System Acceptance Review - Bifrost

Bifrost – NCRs and NITs
=ESS.NSS.H01.BIFRO

PRESENTED BY LIAM WHITELEGG

NCR – 10525 (& NIT-155)

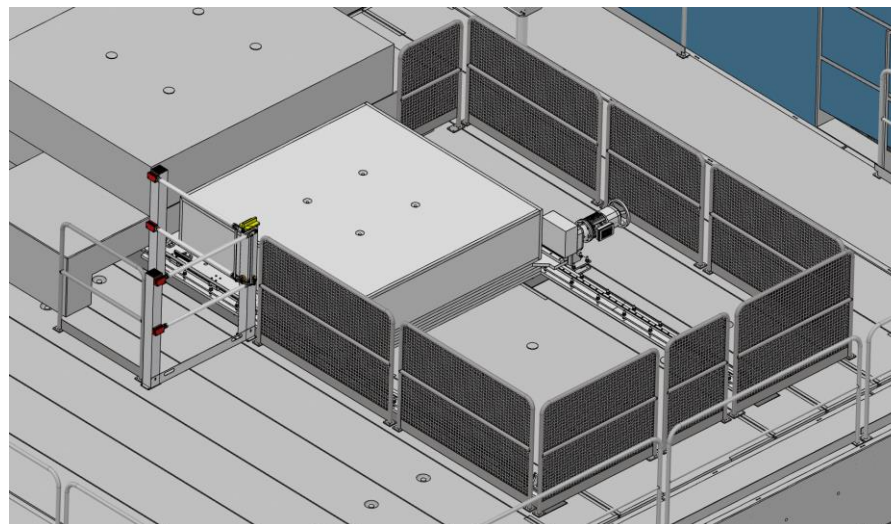
- All documents required for CE marking available in preliminary form
- Following TBL Shutter Process
- ESS decision whether to CE mark or not

Nonconformity:	10525	Absence of CE marking, or related documentation
Nonconformity Details		
Equipment:	BIFRO.A01.R03.R01	1.5.1 Thermal shutter
Location:		
Department:	TD-NSS	
Type:	NCT_0005	Deviation from Technical Documentation
Note:	Absence of CE-marking on equipment or an agreed plan for CE-marking to be conducted in situ and relevant documentation. Owner: Gabor Lazlo Ref doc: ESS-5617654 Instrument shutter test report	
Status:	In Progress	NCR Owner: GABORLASZLO
Severity:	Minor	Related to Radiation Protection/Radiation Safety: <input type="checkbox"/>
Priority:		Related to Security: <input type="checkbox"/>
Permanent NCR:	<input type="checkbox"/>	Related to Information Security: <input type="checkbox"/>
Permanent NCR CHES No.:		Audit: <input type="checkbox"/>
		Related to Conventional Safety: <input type="checkbox"/>

Related to CAVE (9)

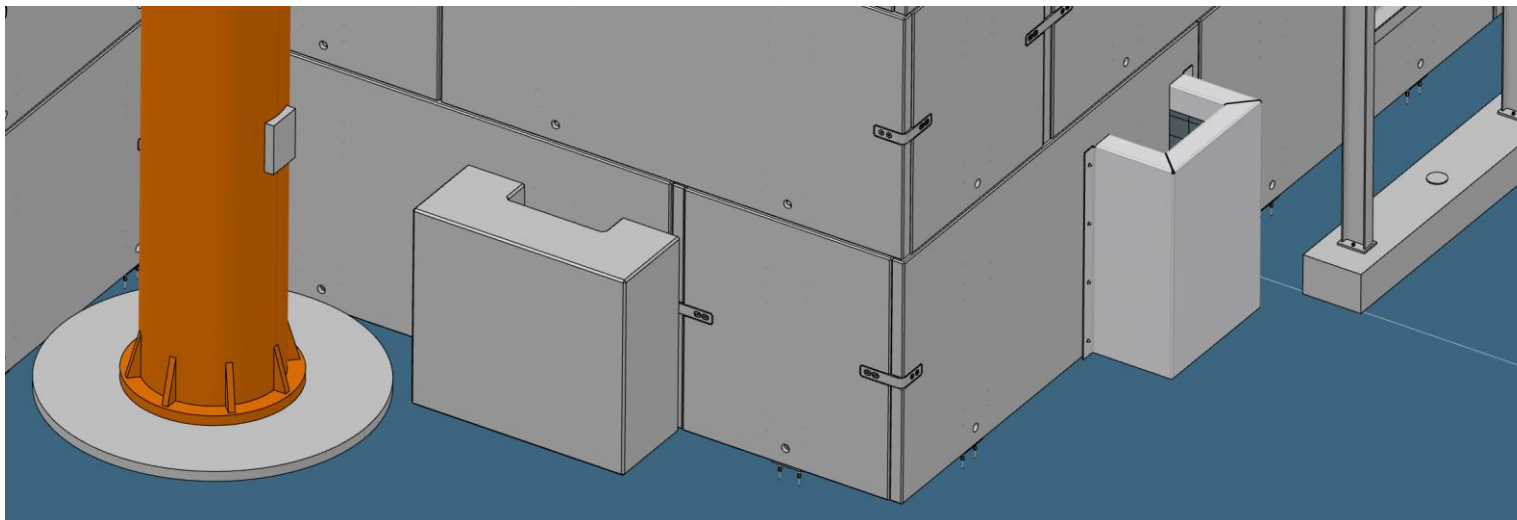
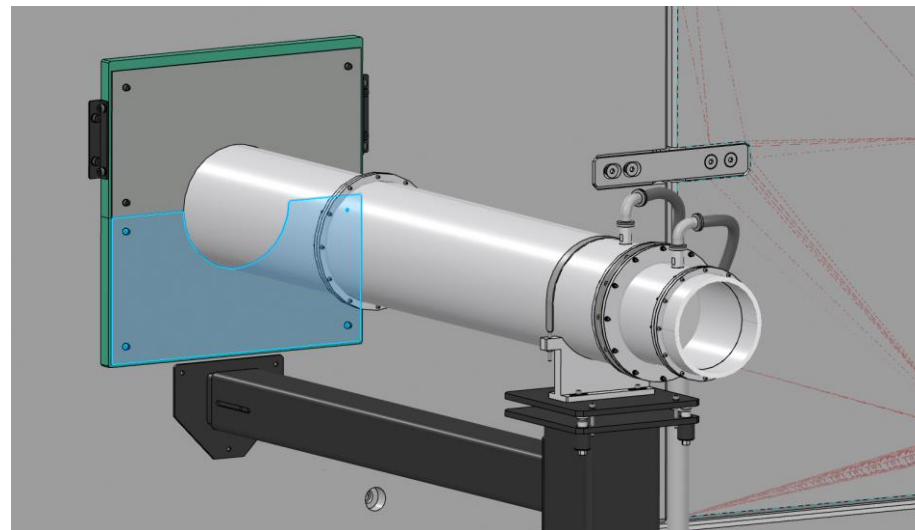
Summary	Issue key	To be resolved by	Notes
Bifrost Cave SAT - Roof Beam Gaps	NIT-226	ORR	To be highlighted as hotspot to RP
Bifrost Cave SAT - Roof Handrails	NIT-227	SAR	Arrived. Installation ongoing and awaiting final pieces
Bifrost Cave SAT - Lead Chimneys	NIT-228	SAR	One almost complete. One lead chimney to be built. One heavy concrete chimney ordered
Installation of Borated Poly Plug in Cave Wall	NIT-251	ORR	Ordered. Delivery Week 40
Bifrost False Floor North Completion	NIT-263	SRR	Awaiting access to bandsaw
Installation of borated lining in service feedthroughs	NIT-264	SAR	Material on site. Awaiting installation
Enlarge Radius on Beam Stop Borated Aluminium Sheet	NIT-303	SAR	Ordered. Delivery Week 40
Change thrust screw to non-magnetic - Bifrost	NIT-21	ORR	Small screws were labelled non-magnetic but clearly are
Bifrost BM4 - Magnetism	NIT-82	ORR	Multiple items on BM4 are magnetic. Some have changed, others need further investigation

Related to Secondary Spectrometer (10)

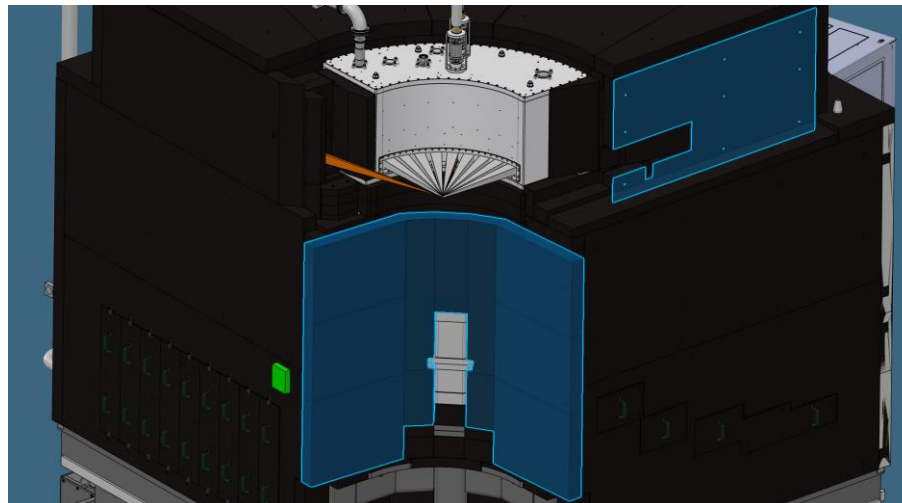
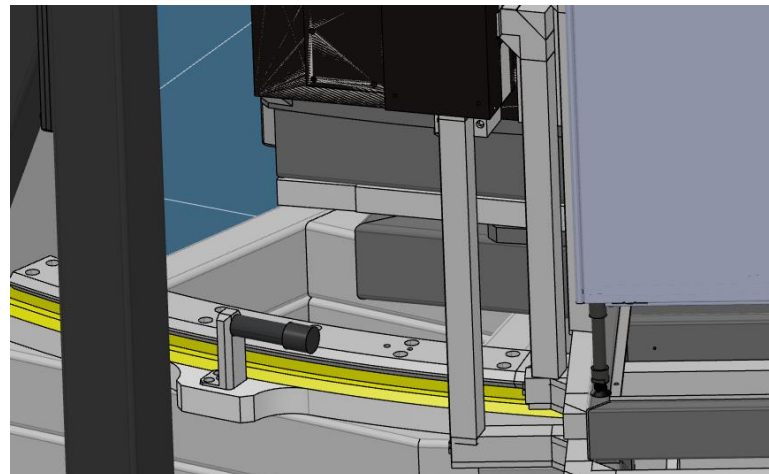
Summary	Issue key	To be resolved by	Notes
Bifrost Analyser - Performance Check	NIT-224	ORR	NIT used to highlight a potential future weakness
Bifrost Spectrometer Polyethylene	NIT-230	SAR	Material ordered. Delivery Week 40
Modify hard stop on the Bifrost tank	NIT-252	SAR	Changed during commissioning. Design ongoing.
Stainless steel parts on BE filter	NIT-29	ORR	Only problematic when/if polarisation upgrade comes in
Bifrost - Beryllium Filter Adjustment System Amendments	NIT-231	ORR	At high end of adjustment range. Harder to align than necessary.
BIFROST - implement warning in NICOS for low LN2 level in filter	NIT-254	SAR	ECDC – Unable to finalise tests due to concurrent work
BIFROST - implement NICOS warning beryllium filter temperature	NIT-255	SAR	ECDC – Unable to finalise tests due to concurrent work
BIFROST - Integrate tank vacuum pressure gauge level in NICOS	NIT-256	SAR	ECDC – Unable to finalise tests due to concurrent work

BIFROST - Integrate filter vacuum gauge level in NICOS	NIT-257	SAR	ECDC – Unable to finalise tests due to concurrent work
Creation of NICOS warnings for filter vacuum	NIT-306	SAR	ECDC – Need to discuss, implement and test alarm

Related to Process Utilities and Cabling (3)

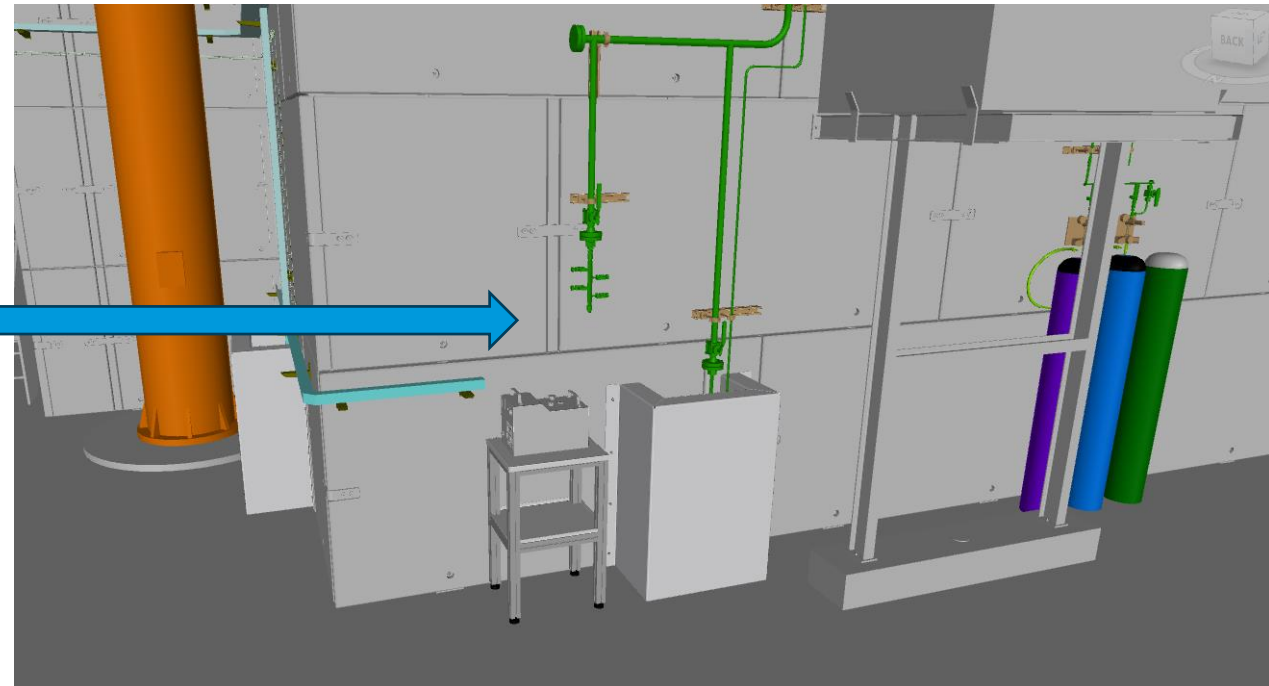
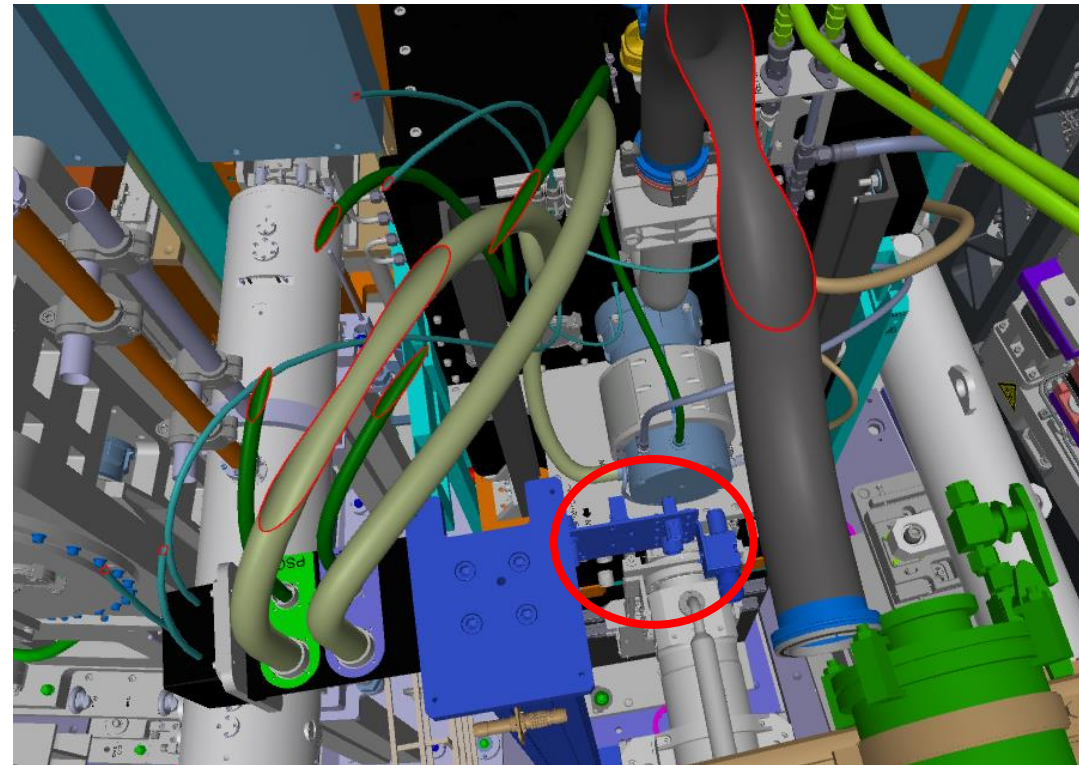
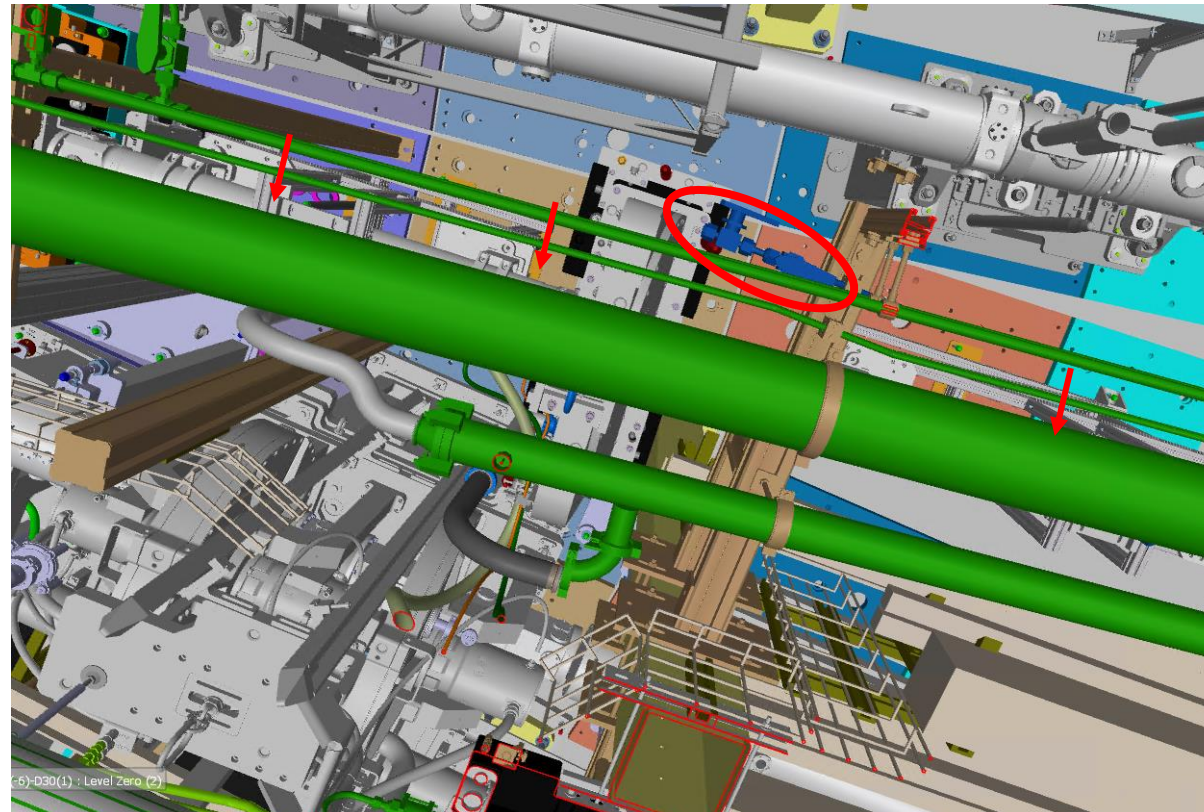
Summary	Issue key	To be resolved by	Notes
CUP Installation of IA Manifold	NIT-232	SAR	Wrong interface installed initially for one pump. New part arrives in October
BM1 Patch Panel and RH	NIT-320	SAR	Potential improvement to the RH accessibility in the bunker
Pipework over Bifrost FOC1	NIT-328	SAR	Pipelines obstructing removal of FOC-1

Related to Grounding (2)

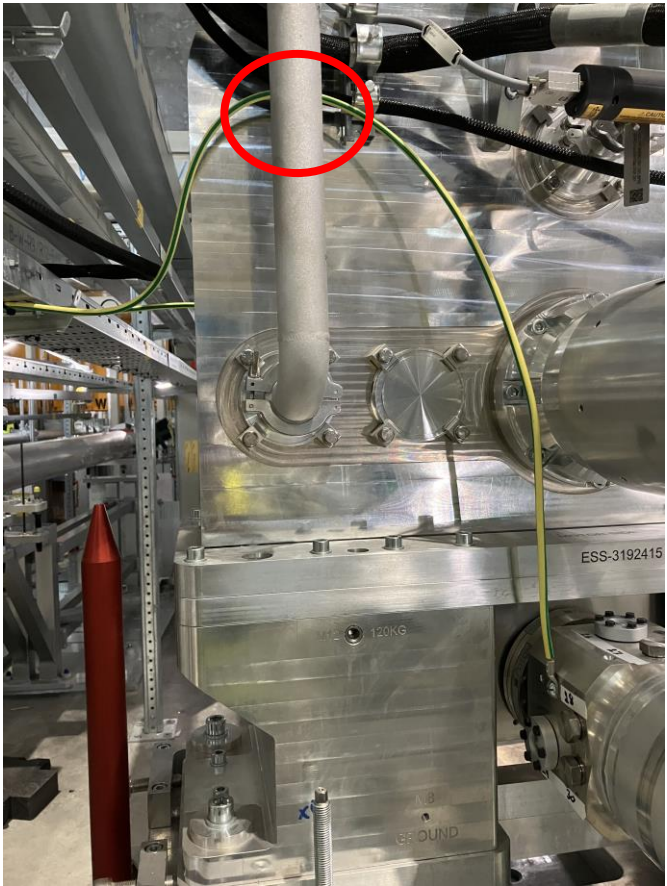
Summary	Issue key	To be resolved by	Notes
Grounding of Components in the Bunker	NIT-241	SAR	Installation Ongoing. Needs amendments
BIFROST Instrument Earthing System	NIT-31	SAR	Below

The BIFROST instrument earthing system is designed to have all components in the instrument zone isolated from the building. These components are connected to the Earth bar in the BIFROST distribution board, which is then connected to the transformer's star point. But during the Detector front-end energization, it was discovered that some racks were not electrically isolated from the building, despite being installed on spacers.

A brief examination was conducted to identify the source of the issue. It was found that the racks were getting connected to the building through the BIFROST distribution board, where all the earth connections meet at the earth bar.

To find the fault location, CEP should disconnect all earth connections to the distribution board one by one, checking for impact on the isolation of the racks from the building.

- Future steps
 - Run detectors and investigate potential sources of noise
 - Unplug cables within front end cabinet and re-check isolation of modules
 - Run tests with relevant technology groups within cave area
